EXPLANATION OF SIGNIFICANT DIFFERENCES

Silver Bow Creek/Butte Area NPL Site (original portion)  
Warm Springs Ponds Operable Unit  
Upper Clark Fork River Basin, Montana

United States Environmental Protection Agency  
June 1991

FIGURE 1 COMPONENTS OF THE WARM SPRINGS PONDS AND MILL-WILLOW BYPASS REMOVAL ACTION

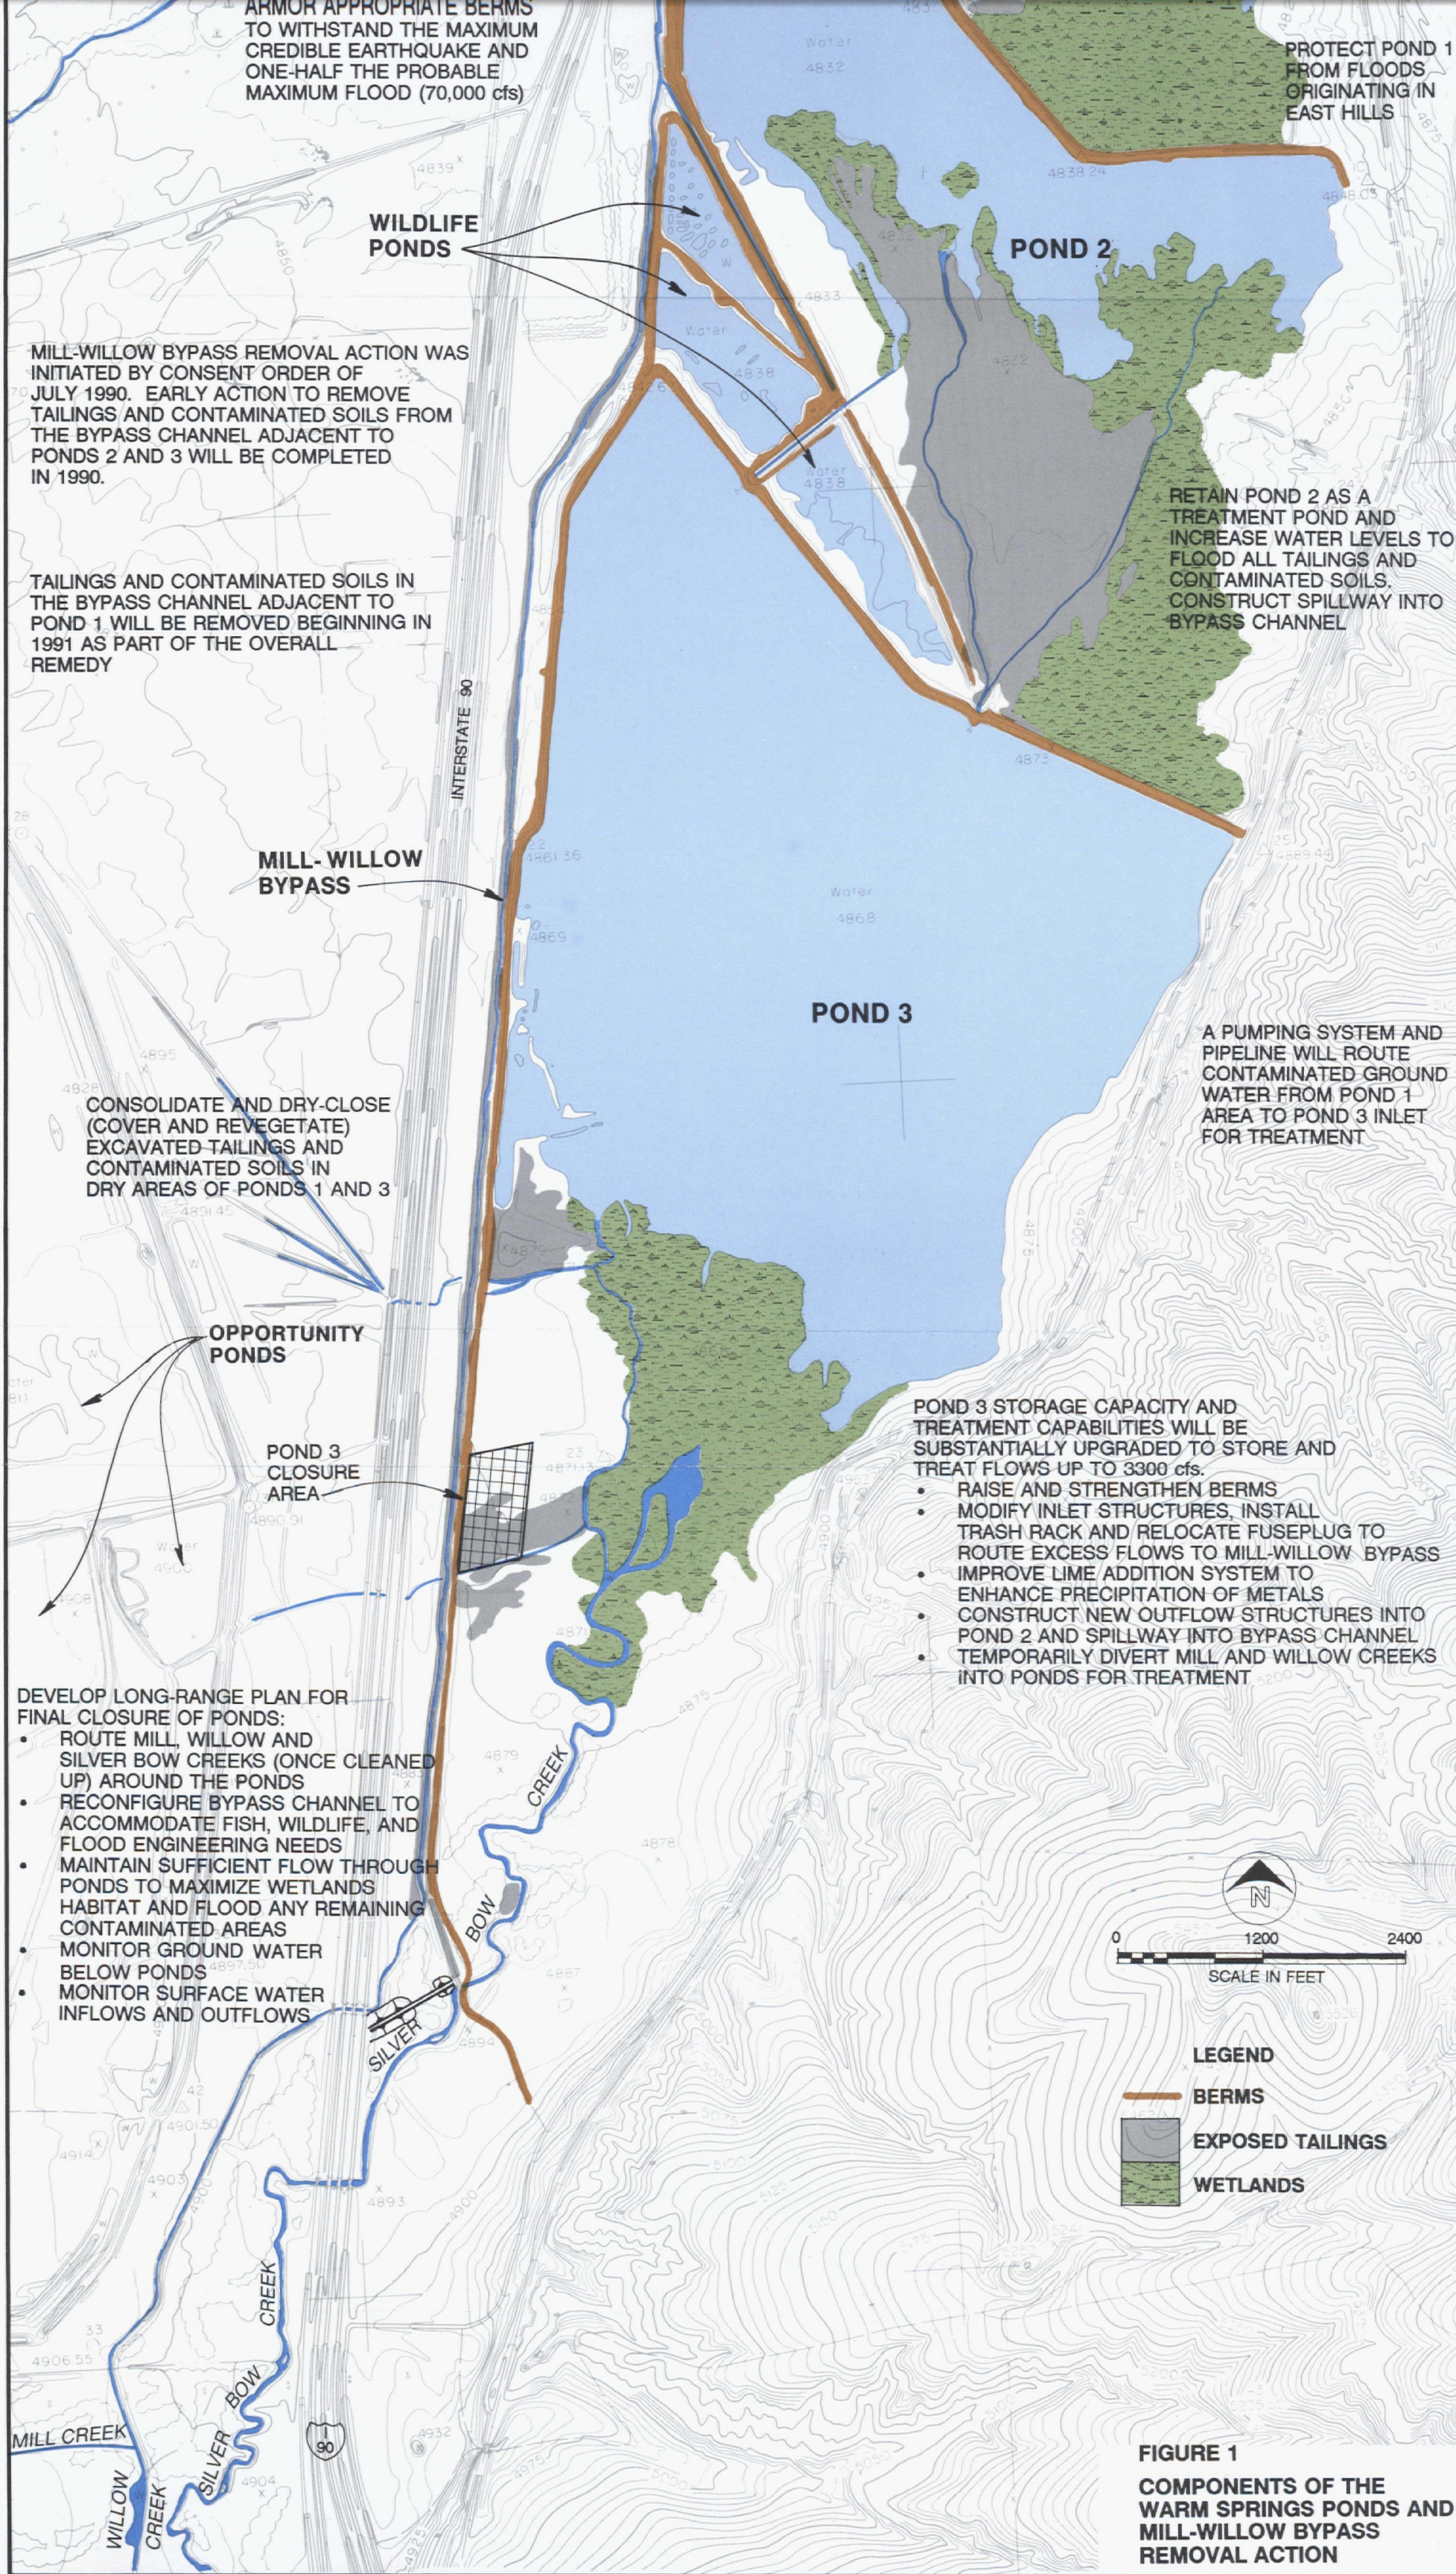
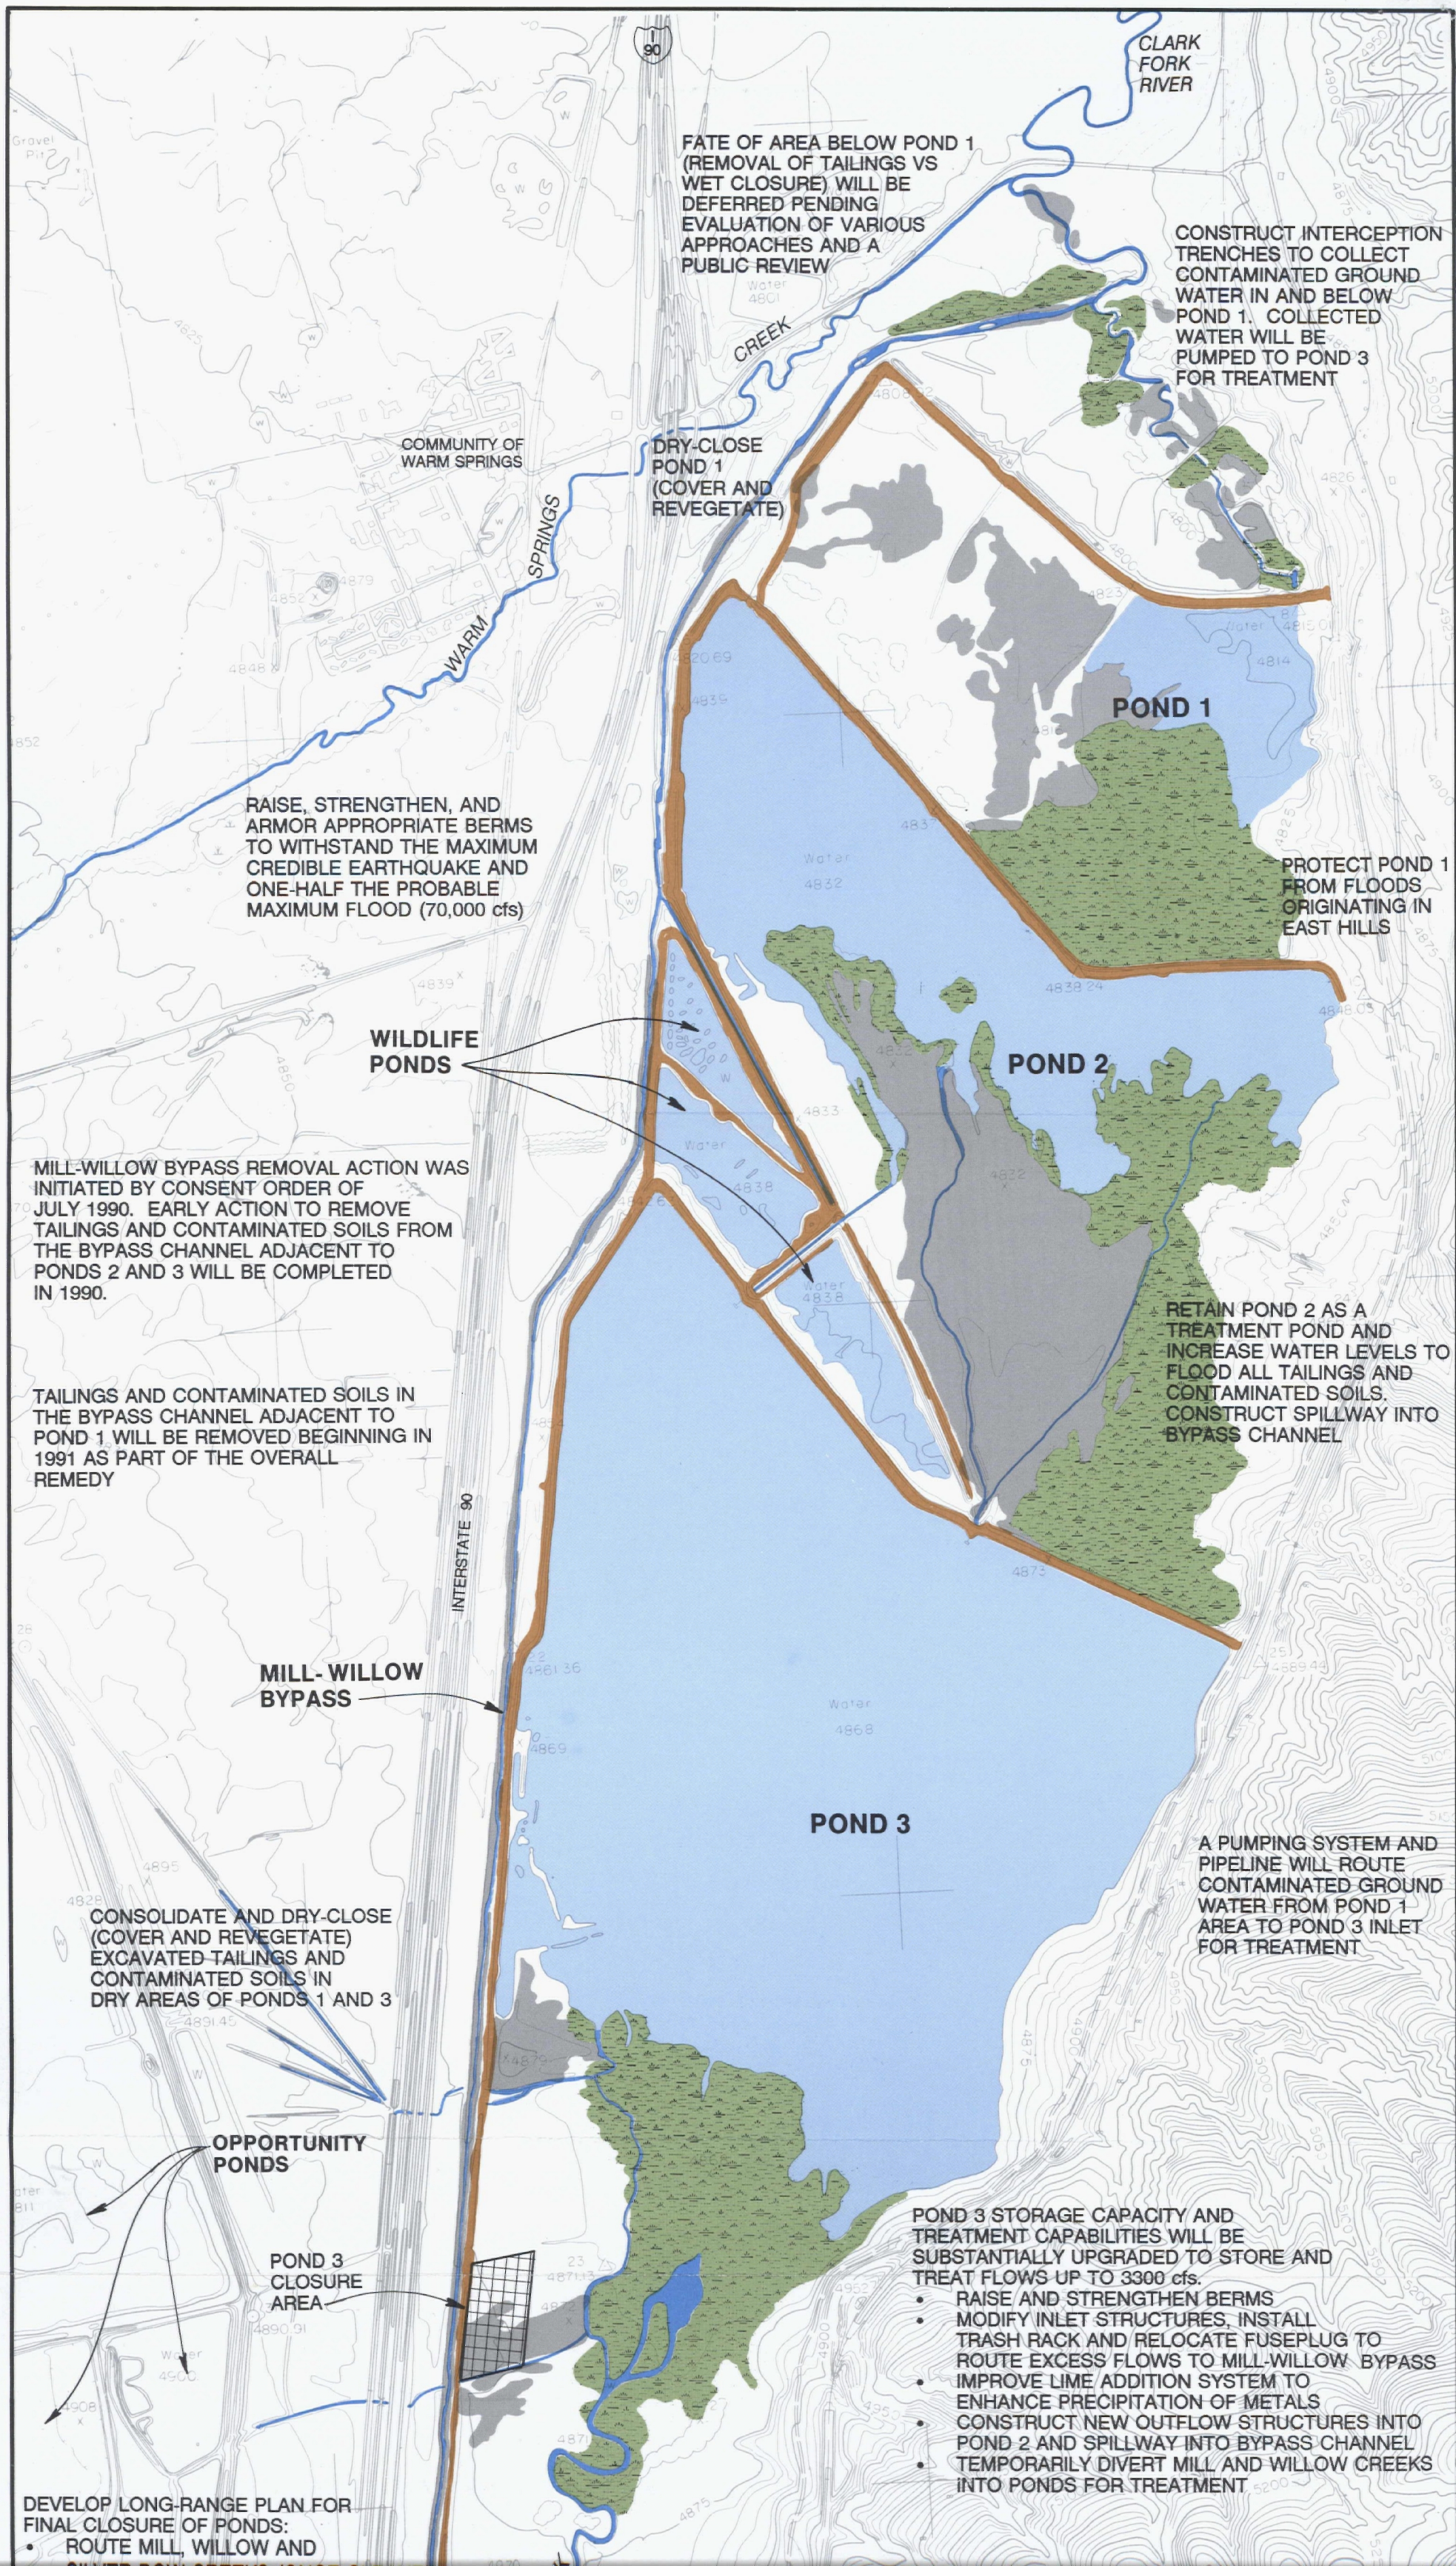
Figure 1 of the Record of Decision shows the location of the Warm Springs Ponds in relation to the four tributaries that combine to form the Clark Fork River below the ponds and it summarizes the remedy. The Warm Springs Ponds cover an area approximately four miles long and one mile wide. Key features include three settling ponds, three wildlife ponds, extensive wetlands areas and the Mill-Willow Bypass.

As stated in the Introduction, only certain elements of the overall remedy have been modified. The most significant change involves Pond 1 and the area below Pond 1, or the inactive area of the Warm Springs Ponds. Thus, Element Nos. 1-7 and 10 (see above) remain essentially unchanged and they either have been or will be implemented without delay, including operation and maintenance activities. These elements of the remedy involve dam safety and flood routing requirements, removal of tailings from the Mill-Willow Bypass, and water treatment improvements. Clarification of certain aspects of Element Nos. 1-7 and 10 is provided below.

The Warm Springs Ponds operable unit, therefore, has been divided into two separate actions. The first action involves the active areas (Ponds 2 and 3, as well as the bypass and berms, inlet and outlet structures, treatment improvement features and monitoring systems). The second action involves the inactive areas (Pond 1 and the area below Pond 1, including the Pond 1

berms, the old Silver Bow Creek channel, and the lowermost portion of the bypass). The second action also involves those decisions deferred by the September 1990 Record of Decision concerning the remediation of contaminated soils and tailings.
